**2015 ICC CODE DEVELOPMENT CYCLE
UPDATES TO THE 2015 PROPOSED CHANGES
TO THE INTERNATIONAL CODES**

The following is a compilation of errata discovered to the Code Change Monograph after the posting of Monograph on March 13th, 2015.

FS 112-15

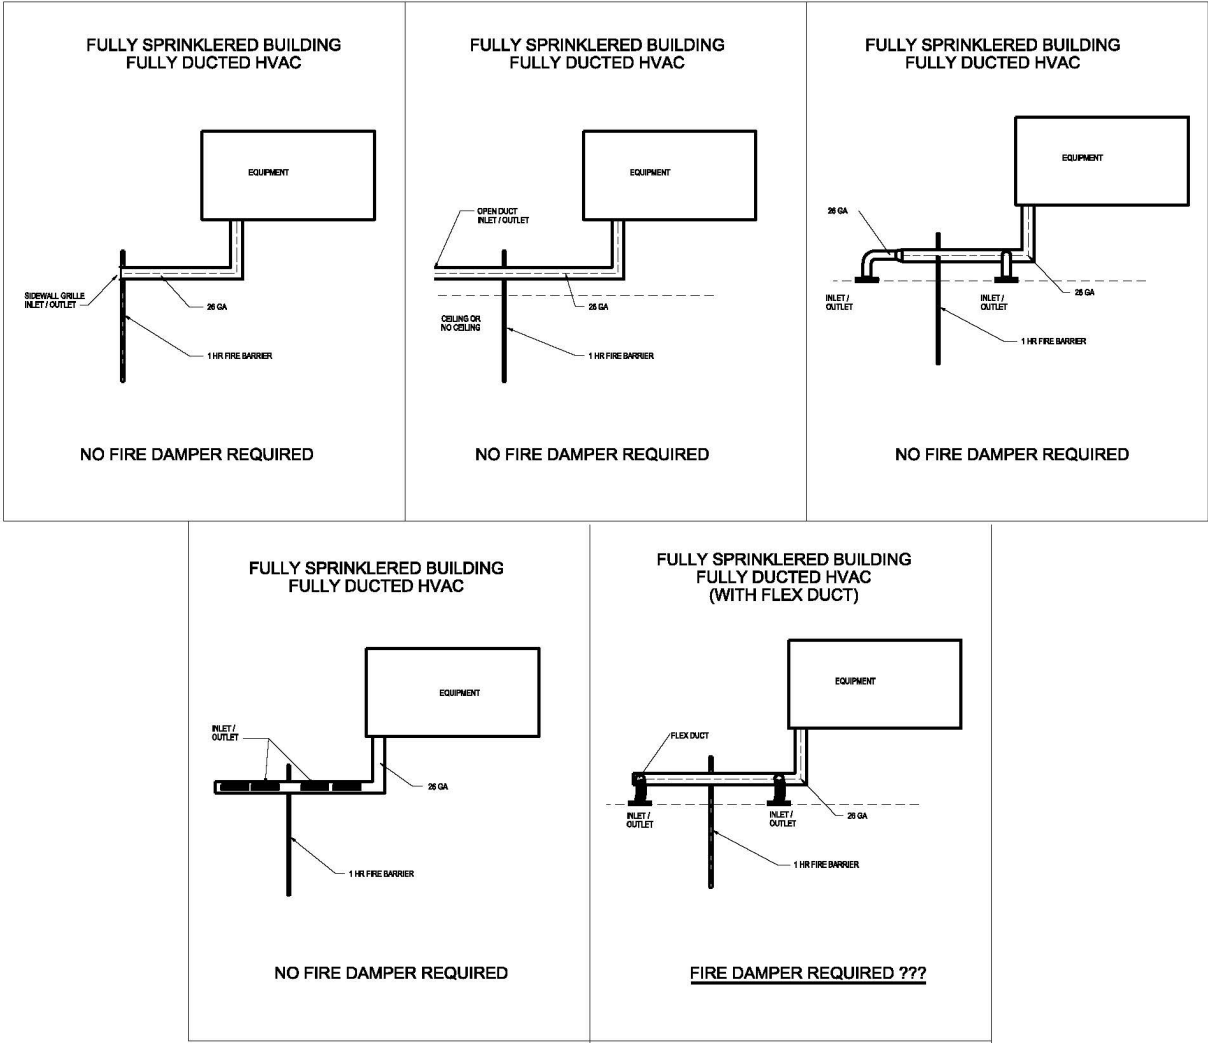
The code permits the omission of the fire damper for a metal duct system that terminates either at a wall (such as a sidewall grille) or continues on to a duct opening past the fire barrier and has openings in the duct ("continuous from the air-handling appliance or equipment to the air outlet and inlet terminals"). This section does not even prohibit openings to be on both sides of the duct as long as the openings are in metal duct. However, for some reason, if flex duct is used to connect a metal duct to a ceiling diffuser (standard practice) this triggers the requirement for a fire damper. See attached sketch.

The flex connection within the concealed space does not constitute a greater hazard than other conditions that would permit the omission of the fire dampers.

Likewise, an flex connection at the AHU within the mechanical space does not constitute a hazard that should trigger the fire damper within the system

3. Such walls are penetrated by fully ducted HVAC systems, have a required *fire-resistance rating* of 1 hour or less, are in areas of other than Group H and are in buildings equipped throughout with an *automatic sprinkler system* in accordance with Section 903.3.1.1 or 903.3.1.2. For the purposes of this exception, a fully ducted HVAC system shall be a duct system for conveying supply, return or exhaust air as part of the structure's HVAC system. Such a duct system shall be constructed of sheet steel not less than No. 26 gage thickness and shall be continuous from the air-handling appliance or equipment to the air outlet and inlet terminals. Flexible connections shall be permitted in the following locations:

1. Non-metal flex connections shall be permitted at the duct connection to the Air Handling Unit or Equipment located within the mechanical room.

2. Non-metal flex connections shall be permitted from an overhead metal duct to a ceiling diffuser within the same room.
